SERVICE BULLETIN

PRODUCT: Computer Monitor
BULLETIN: MON 97-001
MODEL: CQB4147

SUBJECT: Reduce Q404 Failure Rate Causing No Raster

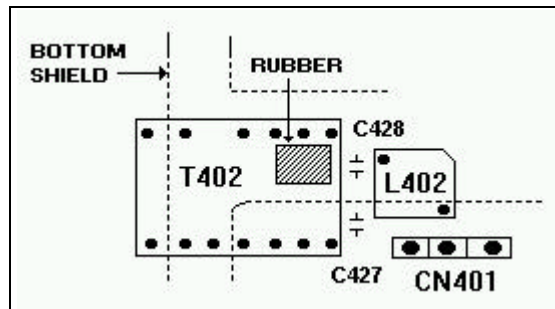
BACKGROUND: A whistling sound is created from harmonic noise generated between T402, L402, and the main PCB near the Flyback Transformer.

SOLUTION: Add a piece of rubber to insulate the main PCB solder side from the bottom metal shield. See Illustration below showing the section of the PCB where the rubber will be located.

Part No.	Description
BH61-30303A	RUBBER

Figure 1

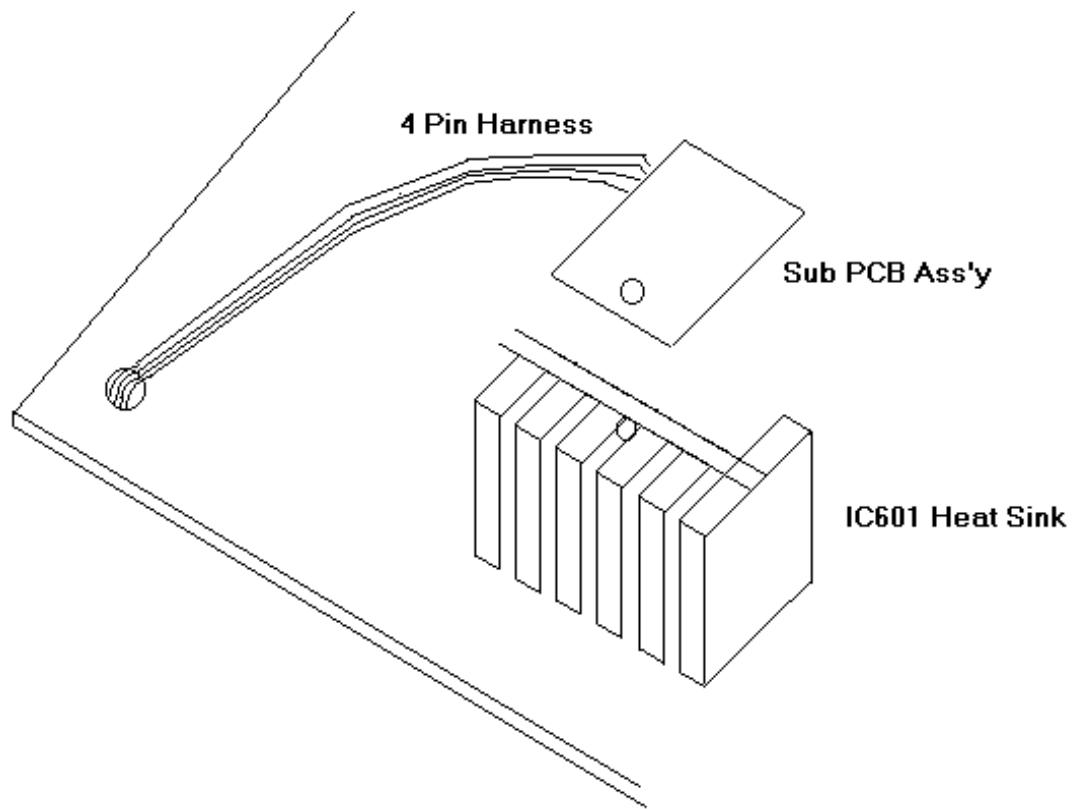
BACKGROUND: Q407 fails due to a transient pulse and current when mode switching from DOS to Windows. This occurs with a Matrox video card installed in the computer.

SOLUTION: Add a sub-PCB assembly as in figures 1 and 2 and a snubbing circuit for the horizontal output as in figure 3.

ORIGINAL			NEW	
Location No.	Part No.	Description	Part No.	Description
NA	NA	NA	BH92-50106J	SUB-PCB ASSEMBLY
NA	NA	NA	BH39-40355S	4 PIN CBF-HARNESS
NA	NA	NA	6003-000129	TAPTITE SCREW
NA	NA	NA	0401-000005	1N4148 DIODE
NA	NA	NA	0402-000012	UF4007 DIODE
NA	NA	NA	2003-000009	220 OMHS, 1 WATT
